Access Compliance Report

Public Rights-of-Way

(Pedestrian Signals)

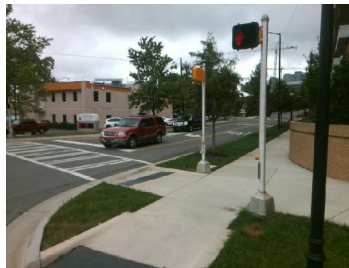
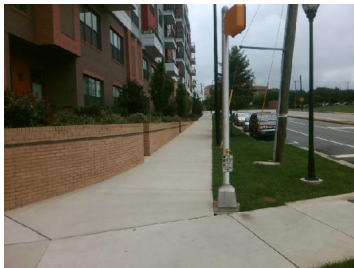
PROW/ADA: TMUTCD 4e.08, R404.2, R406.2

Possible Solutions: Replace Signal Push Button With APS Button on New Post. Remove & Relocate Sign.
